## **SVE BULLETIN**

QVM Bulletin: Q-231

### **F-150 Aftermarket Direct to Battery Connections**

**Models Affected:** All 2015MY and later F-150 vehicles

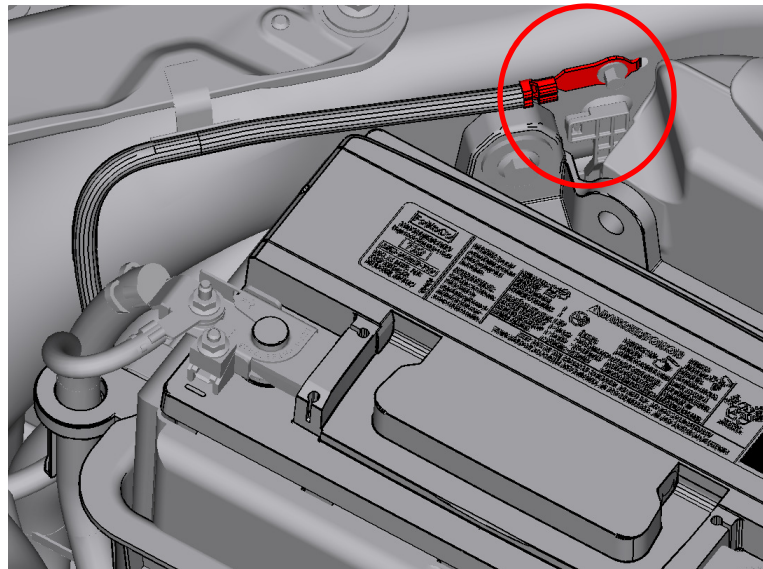
**Description:** The 2015MY F-150 battery charge state is determined with a Hall Effect sensor on the negative battery lead. All negative current must pass through this sensor. Failure to do so will result in malfunction of the vehicle charging system and shortened battery life. **Do not make direct to battery connections at the negative battery post.**

**Procedure:** To ensure proper charging system function, the battery return should be made at the grounding point shown and circled in red in the picture below:

**Addition grounding point specifications:**

Eyelet ID: 7mm  
Bolt: M6  
Torque: 9 +/- 1.4 Nm
